Date: 31 March 2021
To: Health Infrastructure
From: Blackett Maguire + Goldsmith
Subject: **John Hunter Health and Innovation Precinct Project
Access Assessment**

Blackett Maguire + Goldsmith Pty Ltd have been commissioned to carry out an assessment of the proposed SSD Architectural documentation for the John Hunter Health and Innovation Precinct Project against the requirements of Access to Premises Standards 2010.

Figure 5

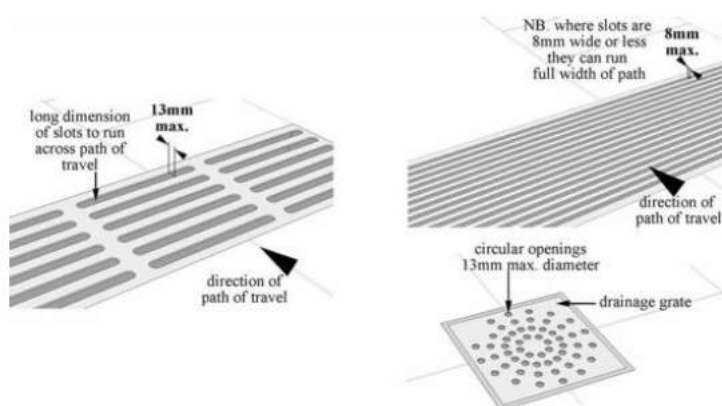
11. Grated stormwater drains located on any paths of travel will need to be fitted with compliant heel guard grates.

Grates shall comply with the following:

- (a) Circular openings shall be not greater than 13 mm in diameter.
- (b) Slotted openings shall be not greater than 13 mm wide and be oriented so that the long dimension is transverse to the dominant direction of travel.

Figure 6

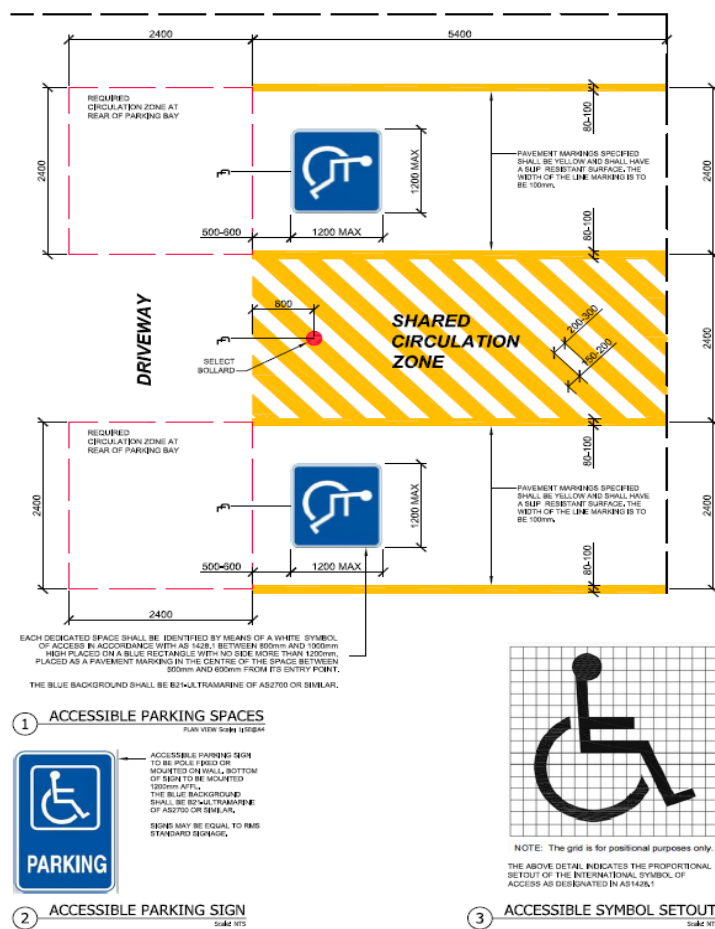
12. Accessible and Ambulant sanitary compartments will be provided within the building in accordance with the requirements of F2.4 of the BCA and AS 1428.1.
13. Accessible parking spaces subject to separate applications, and statutory parking and way finding signage

will be provided to comply with AS1428.1 and AS2890.1 & 6 – refer below as a guide:-

Figure 7

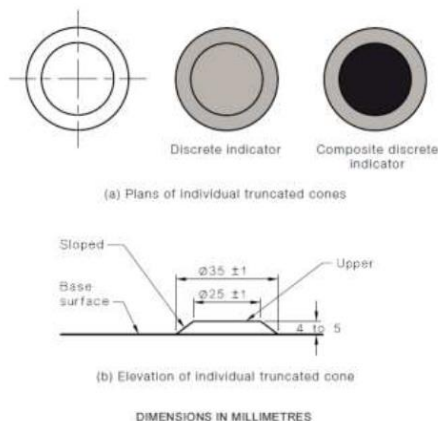
14. The use of TGSIs will be applied to external ramps and stairways only.

TGSIs to warn people of hazards shall comply with AS/NZS 1428.4.1.

The design and arrangement of warning tactile ground surface indicators (TGSIs) shall comply with AS1428.4.1:2009.
